SFD19933
 PLAT 12541
 RR-2.5

DISAPPROVED
Plan Review
 07/18/2019 1:36:02 PM
 dsdarchuleta
 EPC Planning & Community
 Development Department

SITE PLAN LOT 19
 SCALE: 1" = 30'-0"

THE BENNETT RESIDENCE PROJECT
 Owner Name: BLACK ANGEL INVESTMENTS LLC
 Mailing Address: 422 E VERMILIO AVE STE 15
 COLORADO SPRINGS CO 80903-3791
 12070 SILVER CONCHO TRAIL
 Legal Description: LOT 19, THE TRAILS FILING NO. 8
 SCHEDULE: 4217007021
 LAND AREA: 2.53 ACRES 110.207± SF

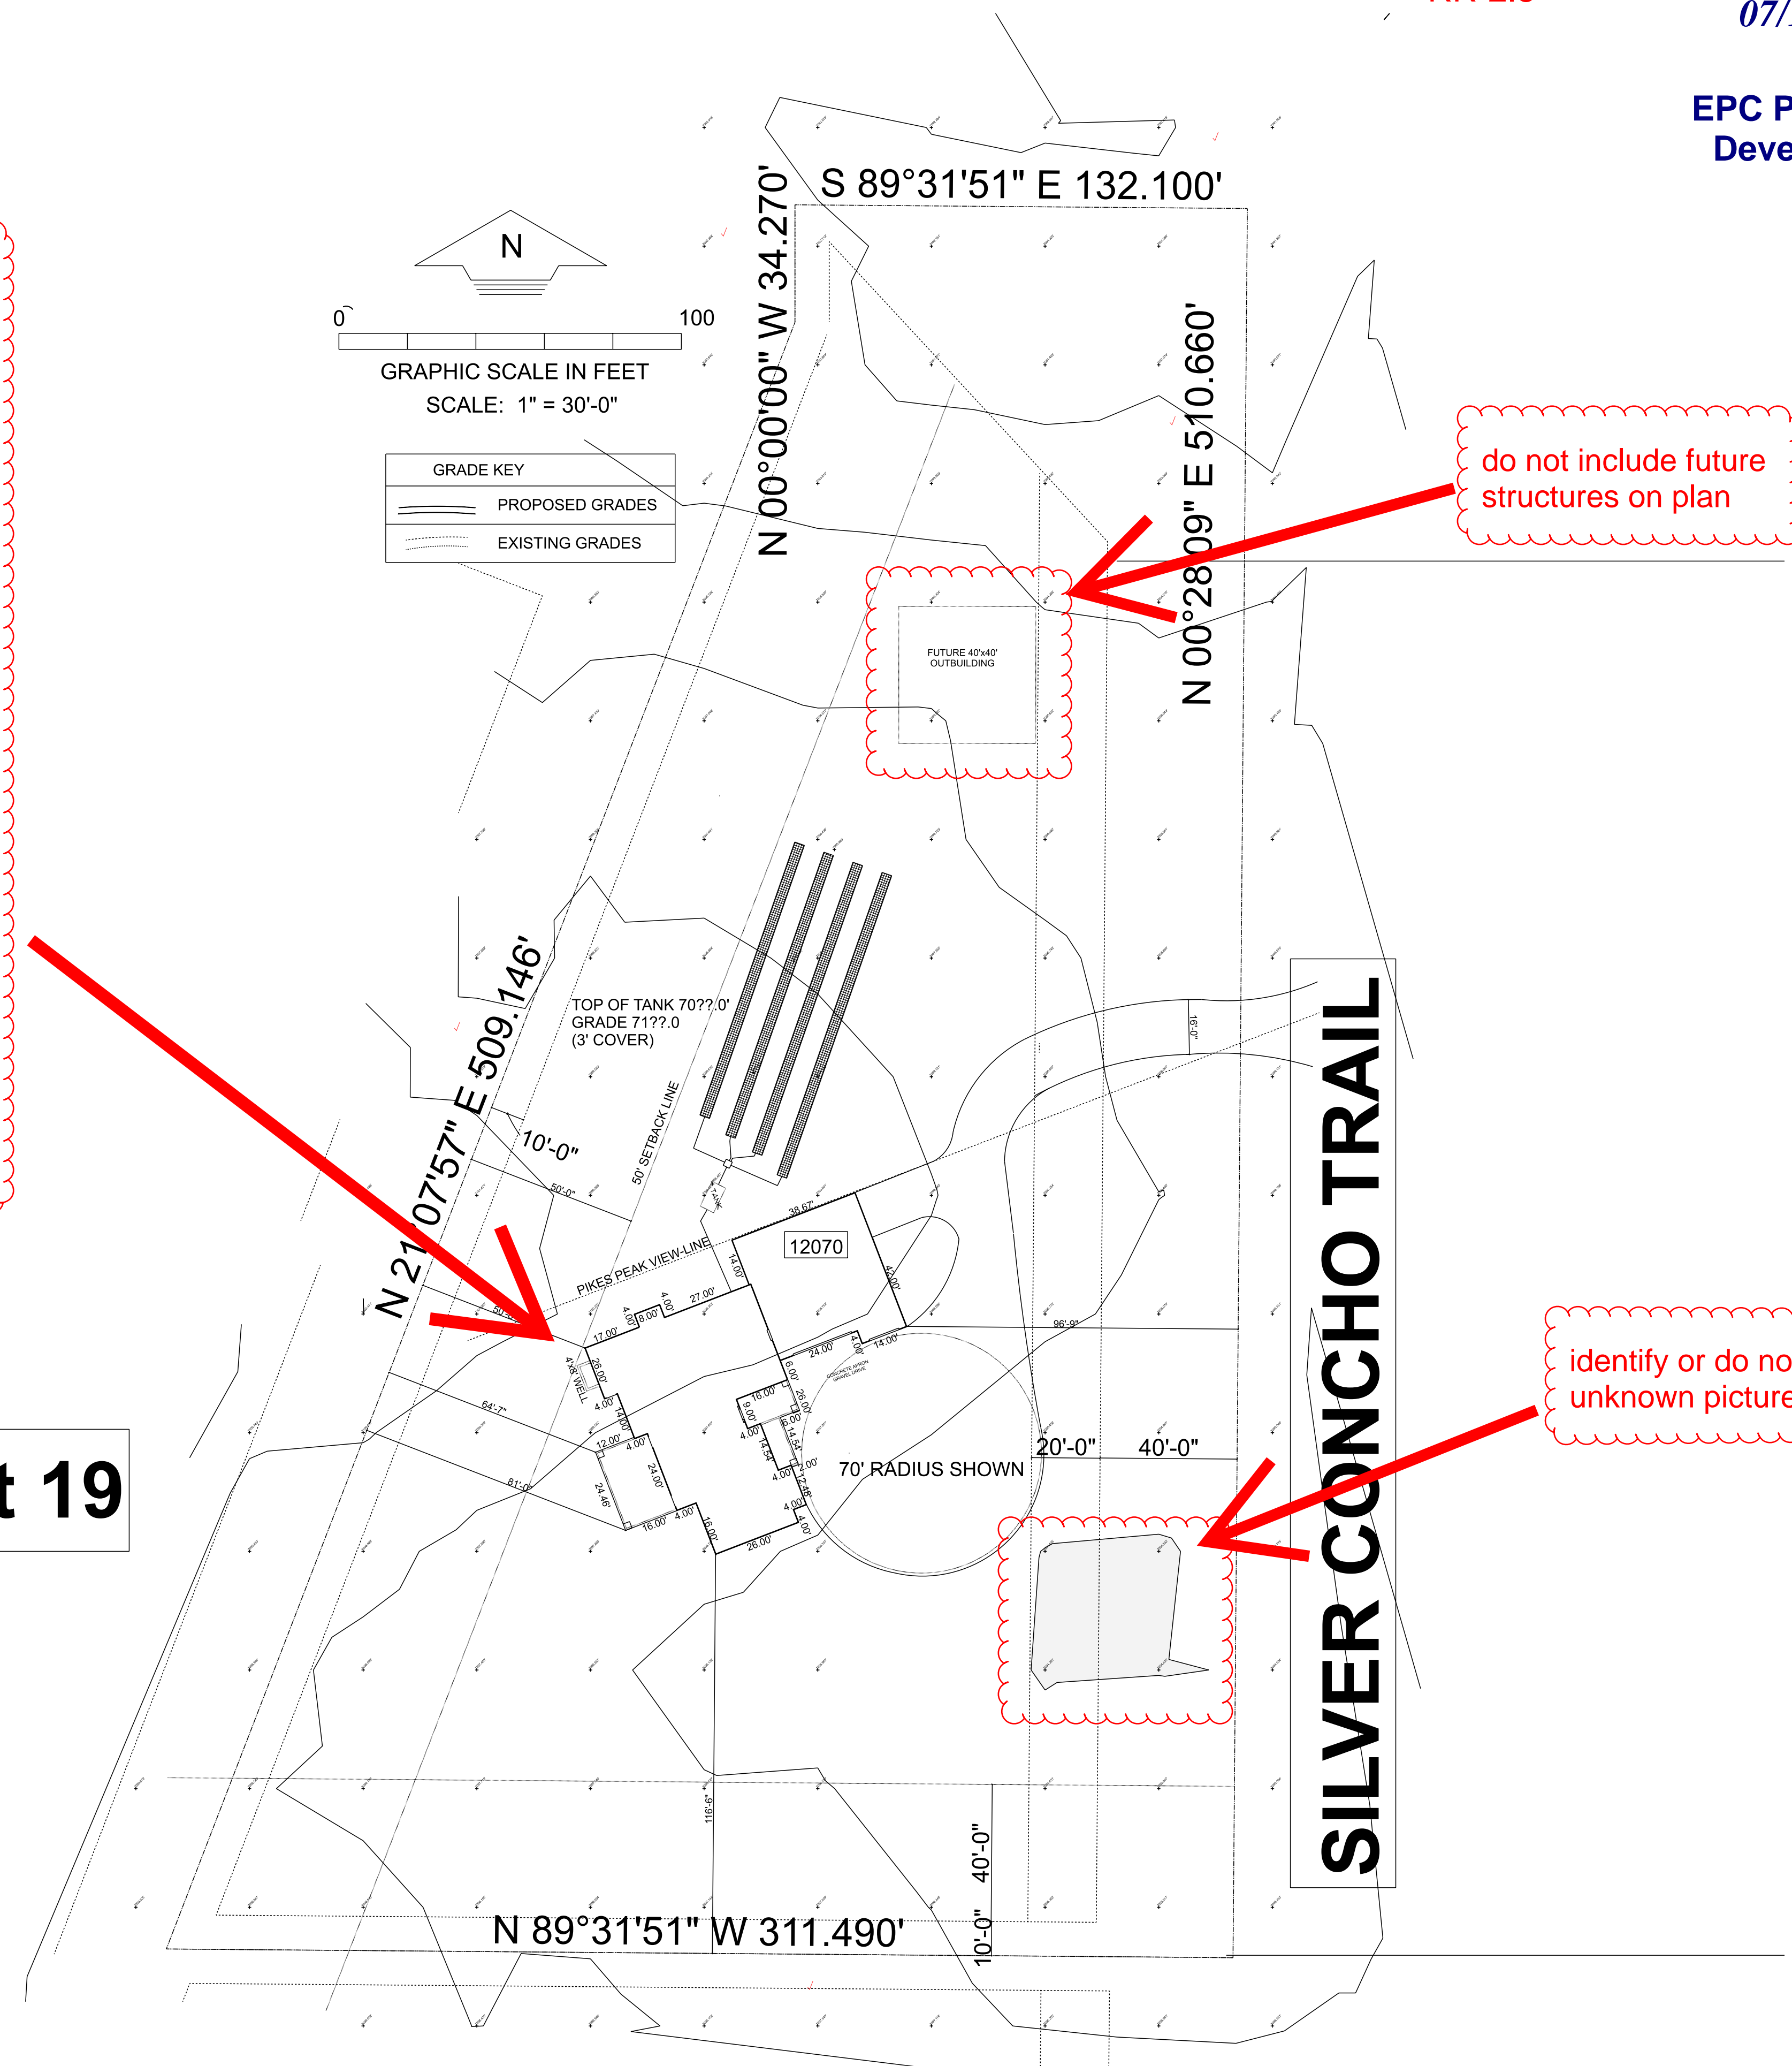
DISAPPROVE:
 1) BESQCP disapproved because
 ESQCP is required (see notes)
 2) remove a future structure
 3) remove all unknown shape

do not include future
 structures on plan

identify or do not include
 unknown pictures

Imperviousness - rough calculation of area impervious being 1226 sf or 11.12 %

ESQCP REQUIRED
 Single-family residence building site greater/equal 1 acre of land disturbance located on a lot or parcel with the total area greater/equal to 2.5 acres or zoned agricultural land and with a proposed total site imperviousness of (10%) up to 20%

Source: Appendix I Stormwater Quality Policy and Procedures - revisions Table I-2 ESQCP and BESQCP Permit Applicability Guidance
